ENGINE - LP COMPRESSOR - LPC BLEED VALVE LINKAGE SYSTEM WITH IMPROVED DURABILITY -
CATEGORY CODE 8 - MOD.ENG-72-0133

V2500-ENG-72-0133

Installation of the Guide onto the Synchronizing Ring
Fig.3 (Sheet 5)

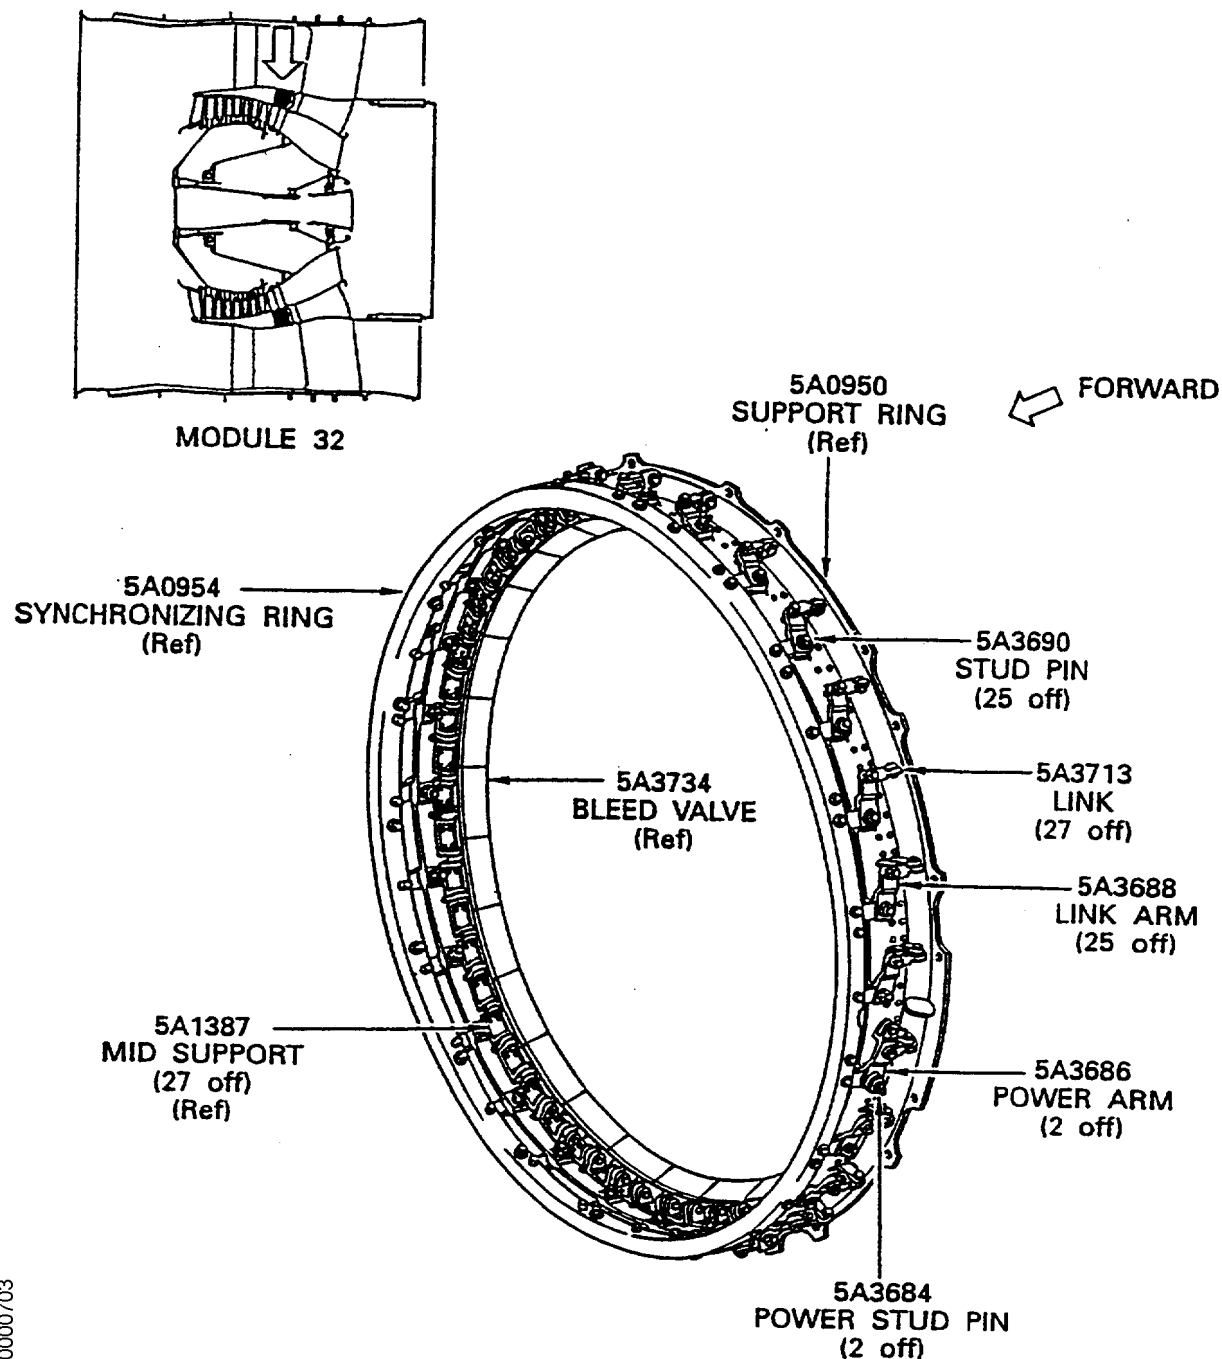
| (k) | Install the 5A0956, Guide, A/O and the MS15795-809, Washer onto the Synchronizing Ring. | Refer to Figure 3

| (l) | Visually and dimensionally examine the formed Guide, A/O. | Refer to Figure 3
